Public Input No. 640-NFPA 70-2026 [Global Input]

Public Input No. 1005-NFPA 70-2026 [Global Input]

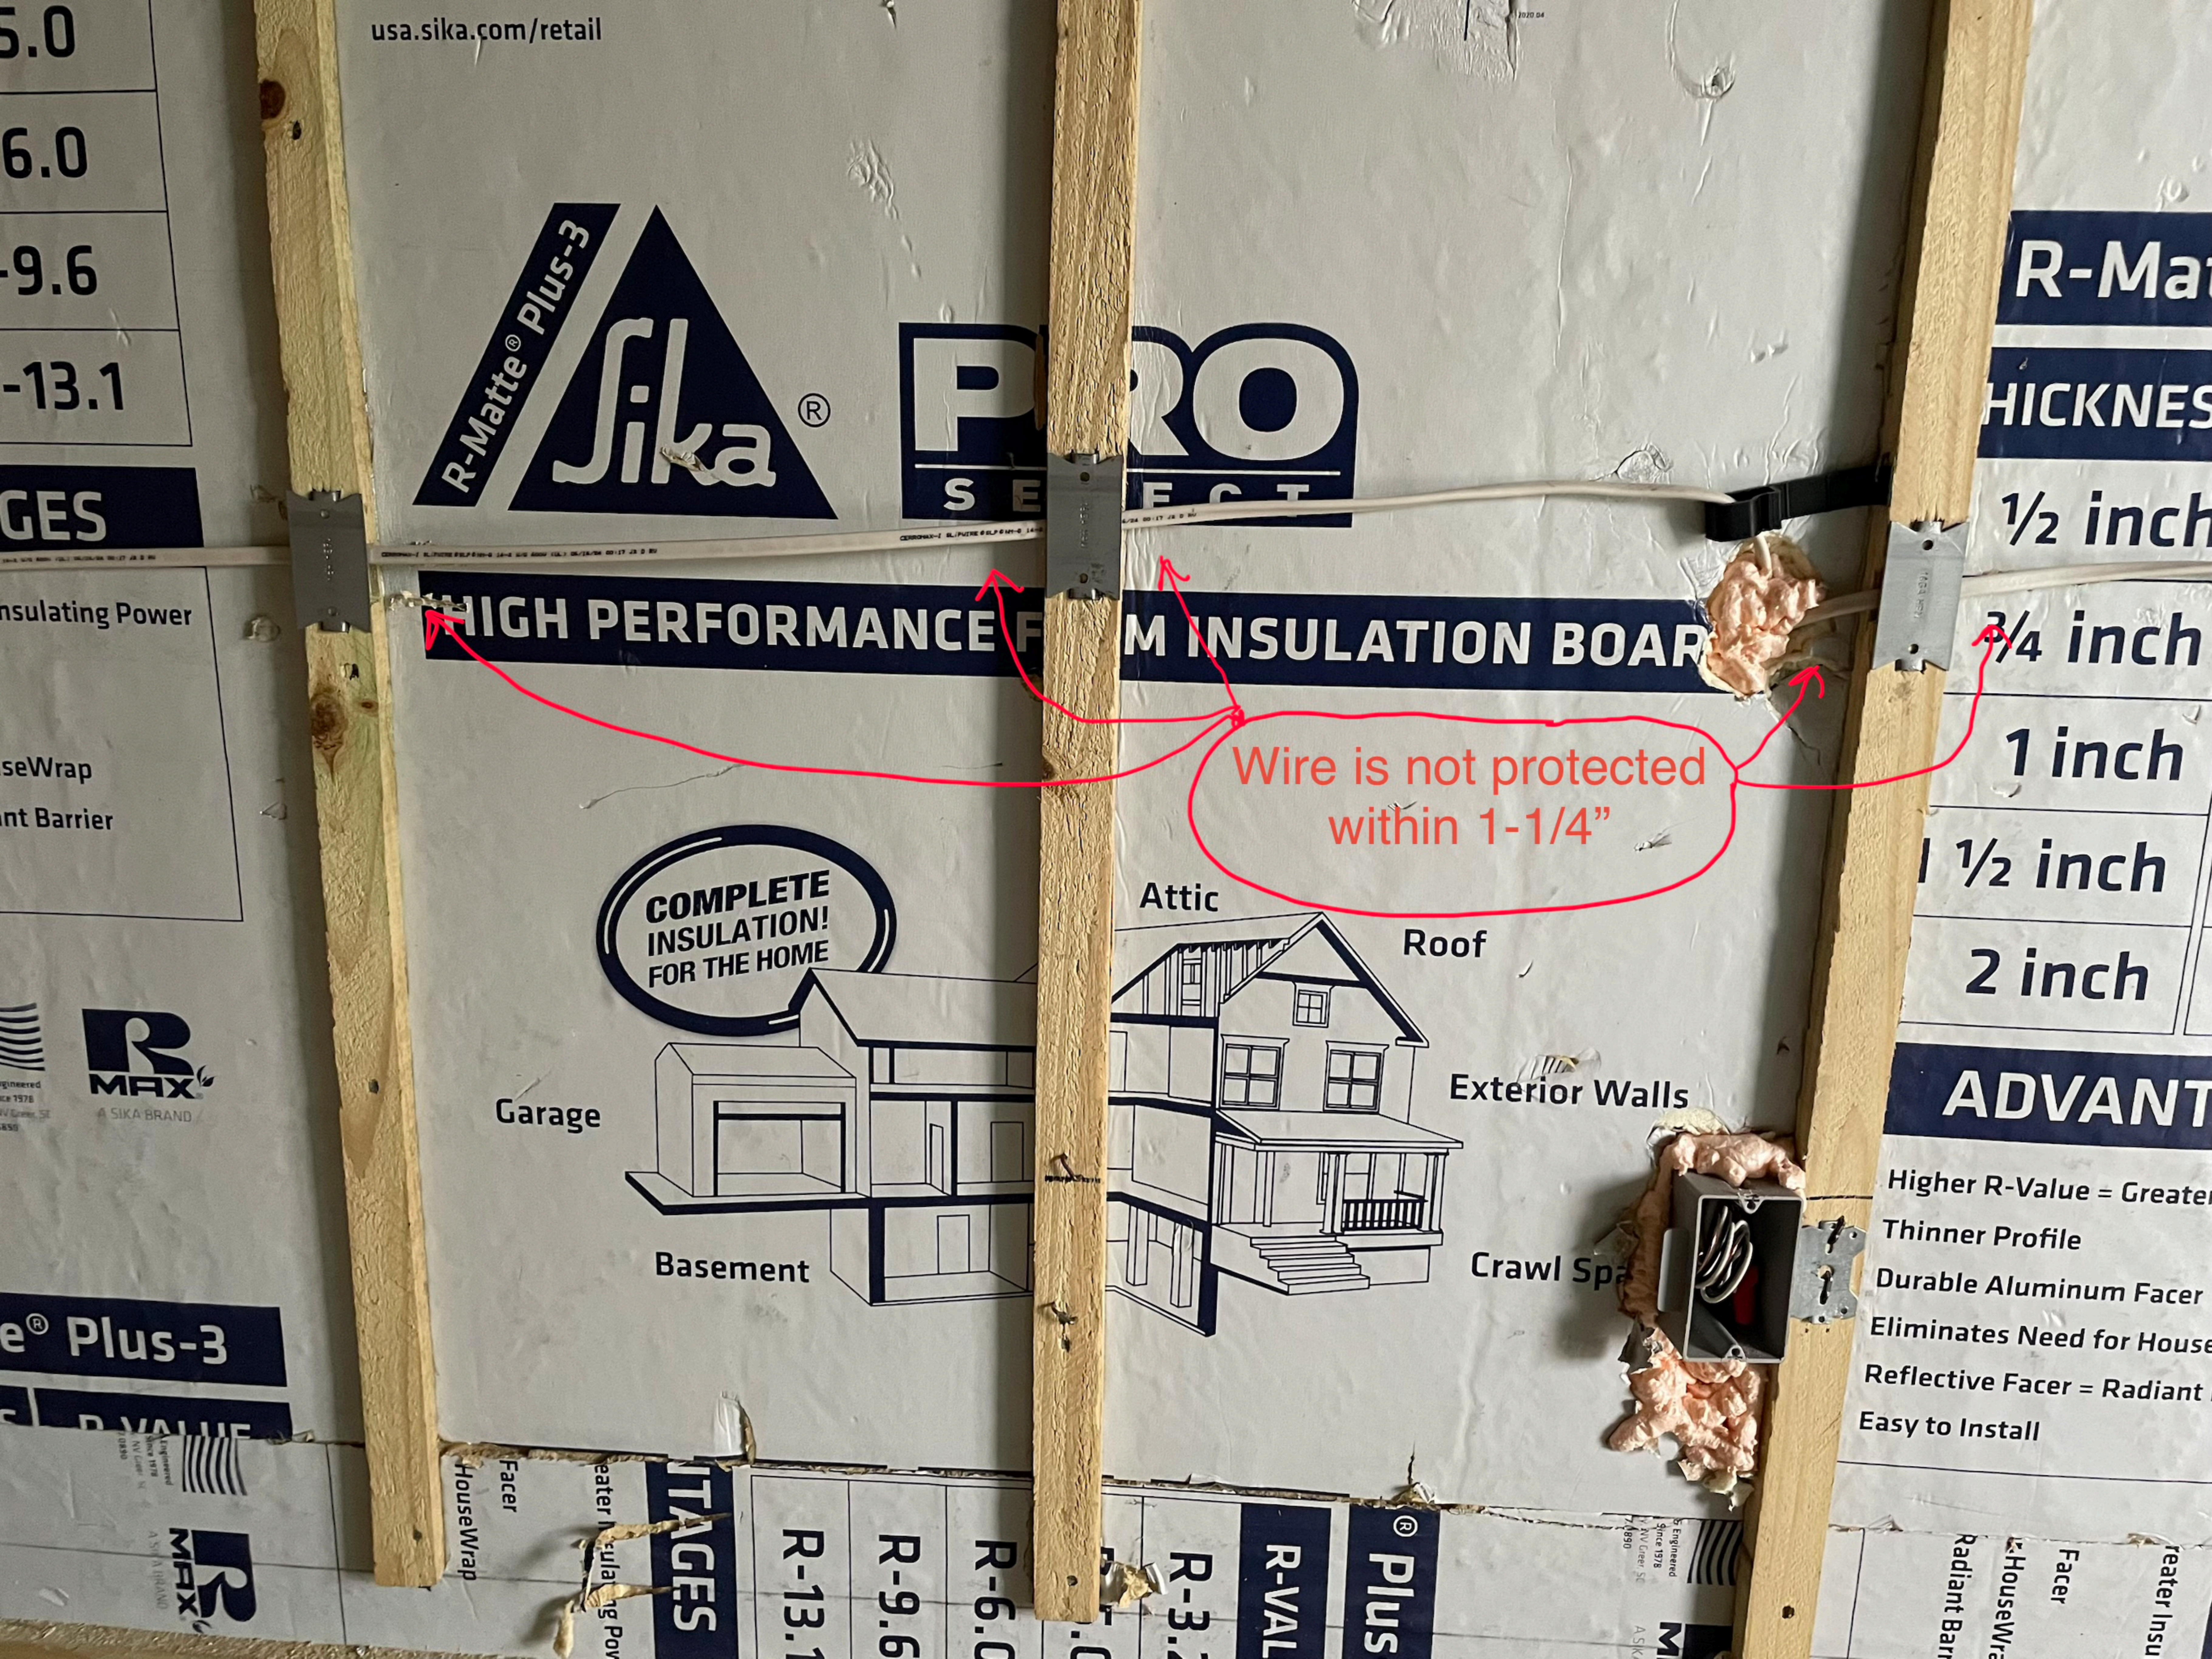
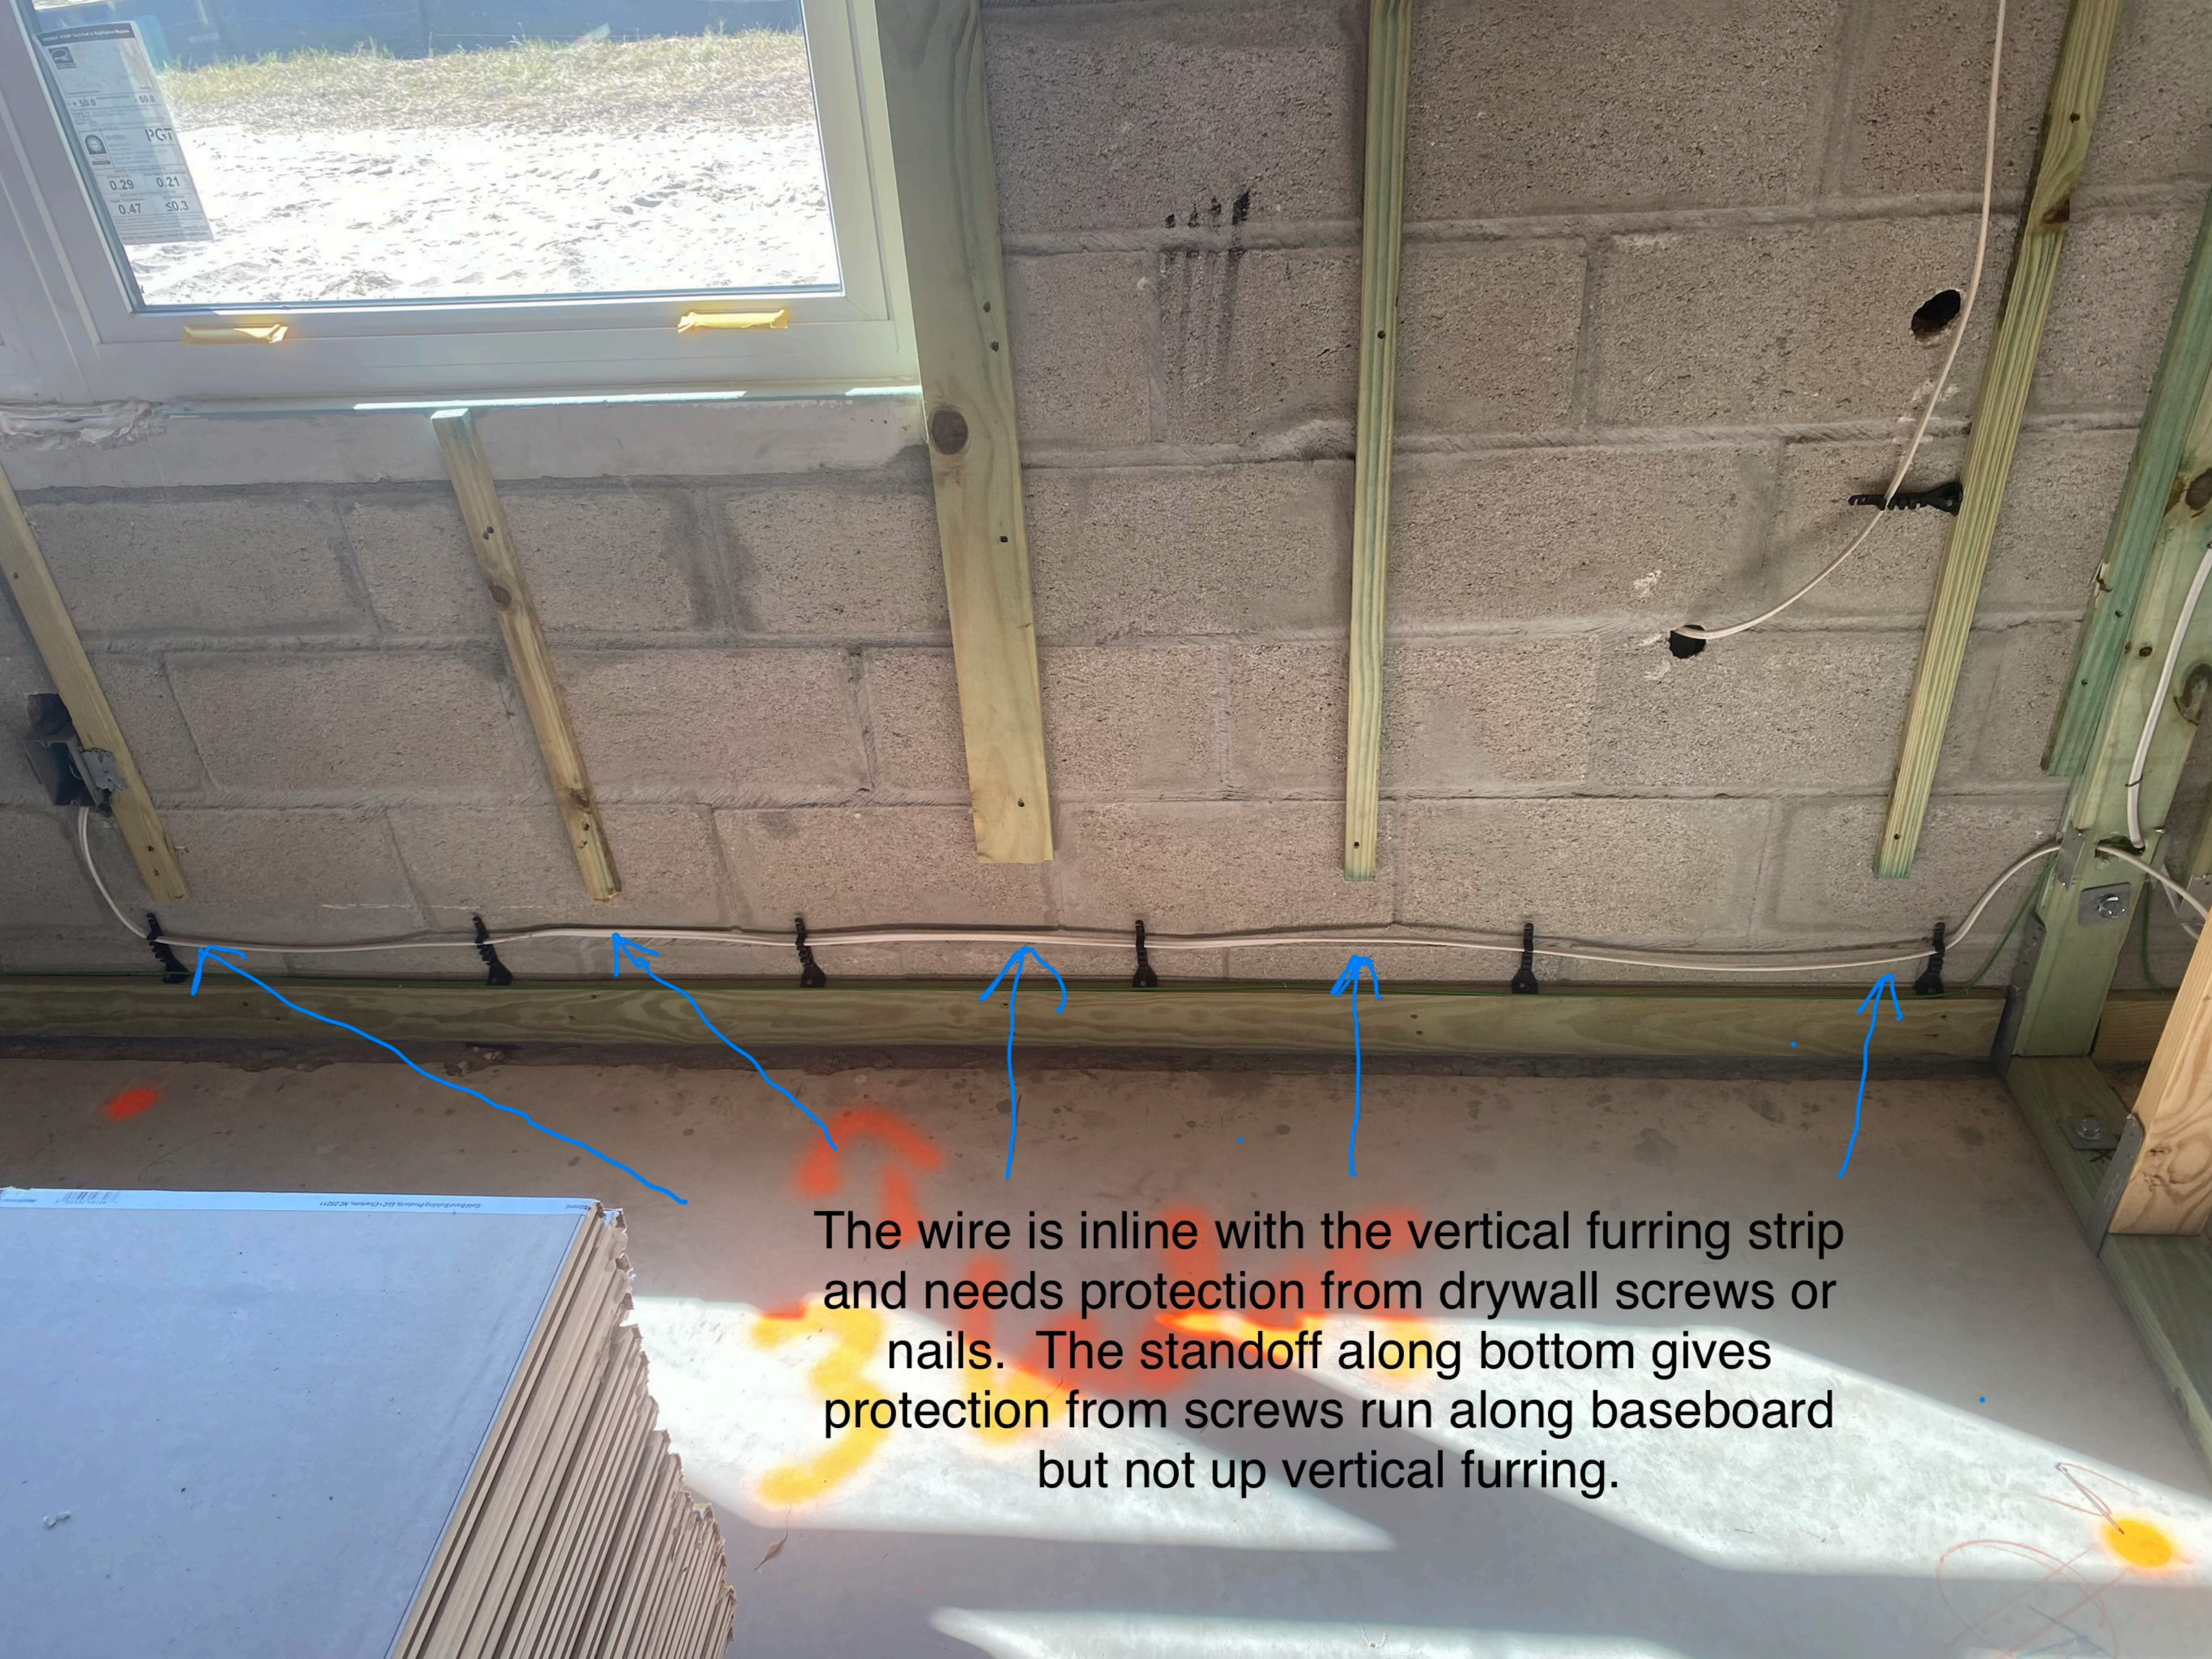
The problem is that the code article is not being interpreted that way in the field by contractors or inspectors. The intent of the code it seems is being lost. So I would like to try again (my 3rd time) to clarify the code and its intent that the wiring shall be protected within 1-¼" inch from the side of the framing member also.

The wire is inline with the vertical furring strip and needs protection from drywall screws or nails. The standoff along bottom gives protection from screws run along baseboard but not up vertical furring.

New text can be added in bold to 300.6 (A) (1 &2) below *a steel plate(s) or bushings at least 1.6mm (1/16in.) thick, and of appropriate length and width **not less than 33mm (1-¼ in.) on each side of the wood member.***

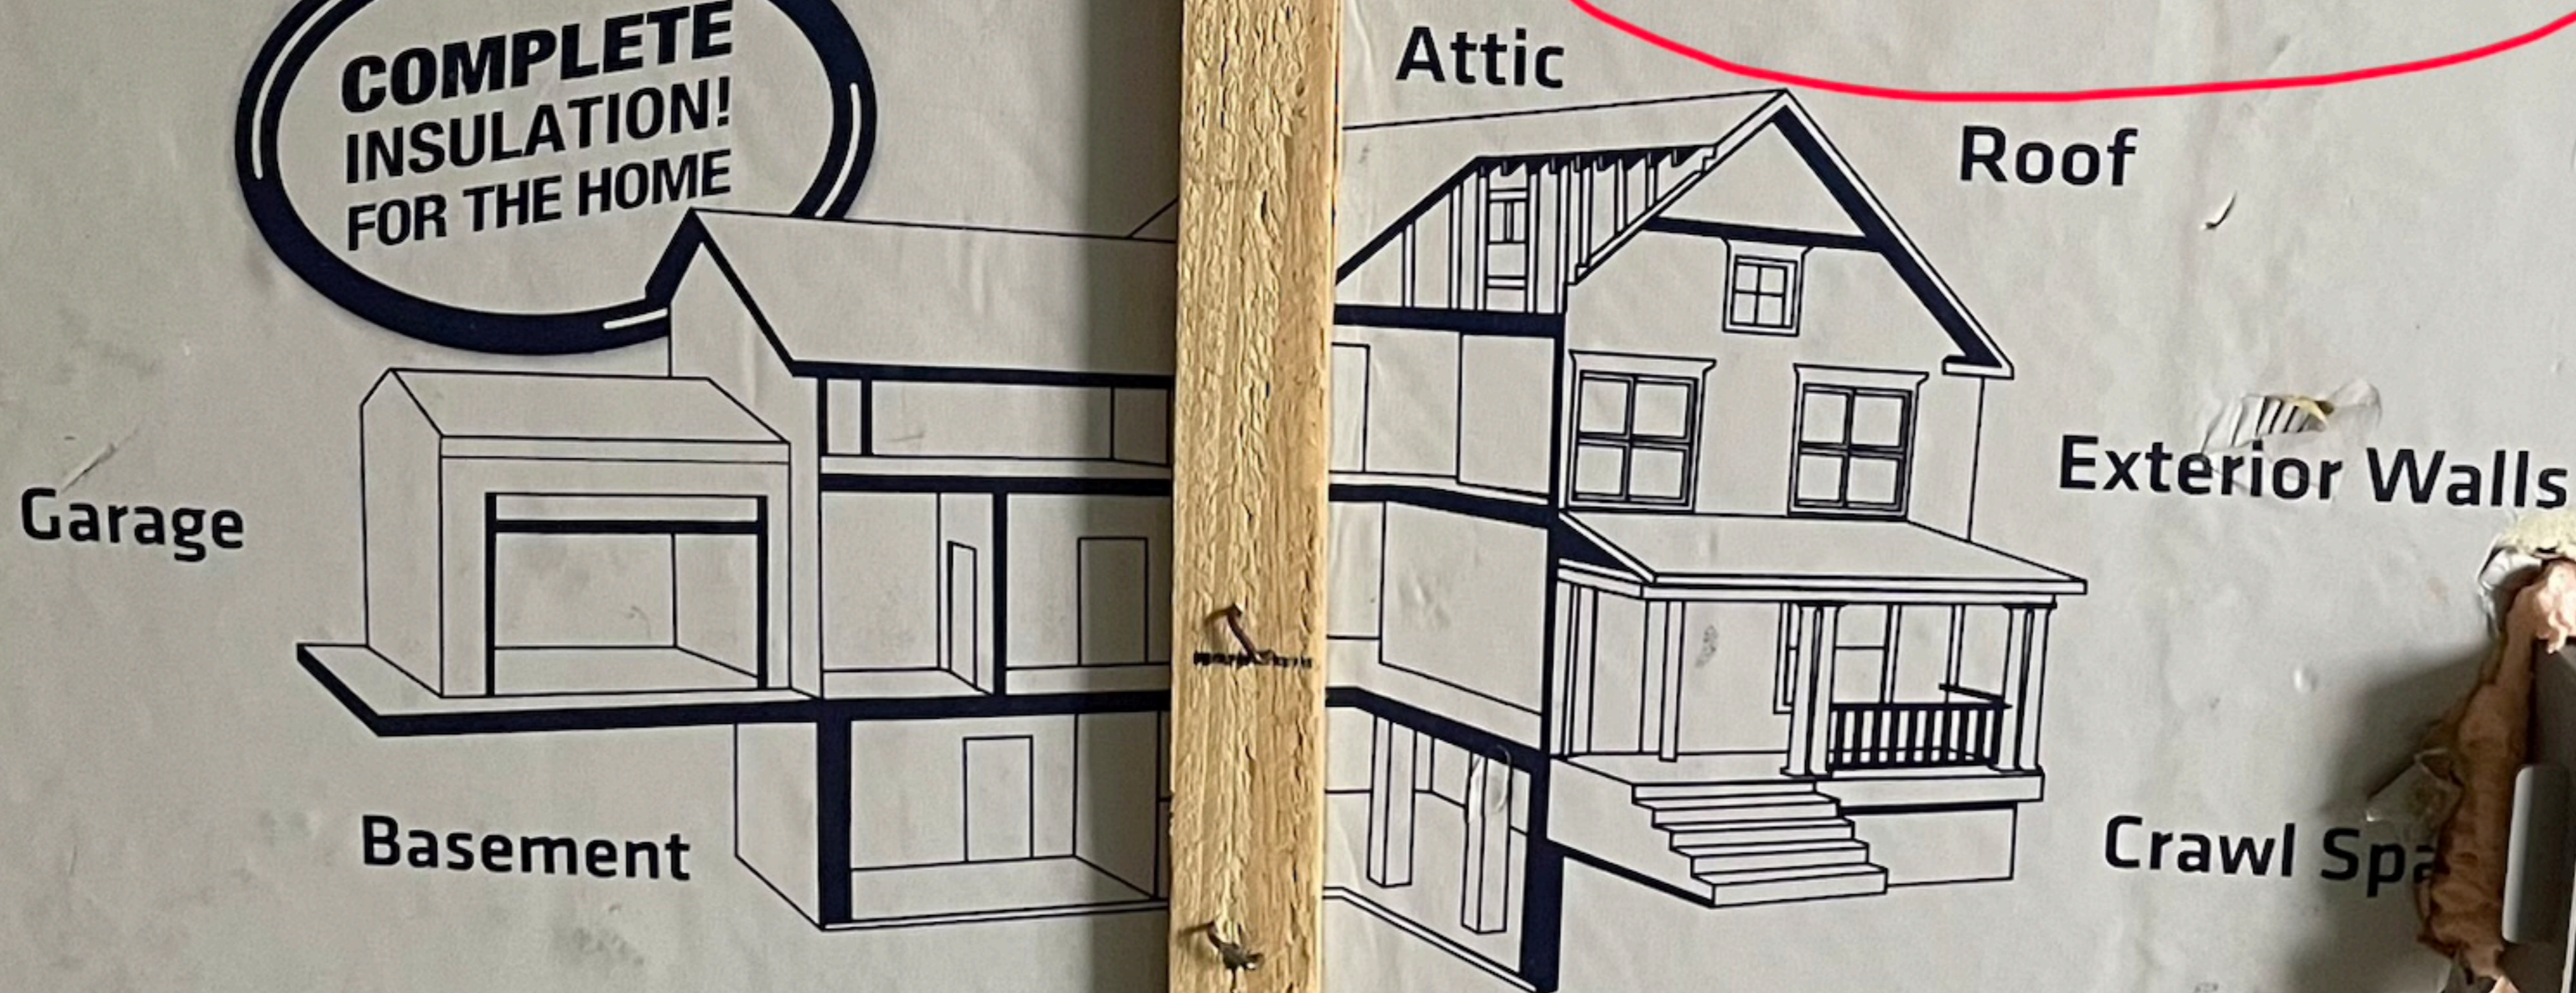
Field installations involving furring strips on masonry or block walls routinely fail to provide the required 1¼-inch protection zone as intended by NEC 300.6(D). Furring strips are typically ¾ inch thick, which makes it impossible to maintain the minimum 1¼-inch clearance from the face or side edge of the framing member. As a result, cables installed horizontally across furring strips remain vulnerable to physical damage from nails or screws, with protection limited only to the immediate area directly over the strip.

Wiring is not protected a 1-1/4" from furring
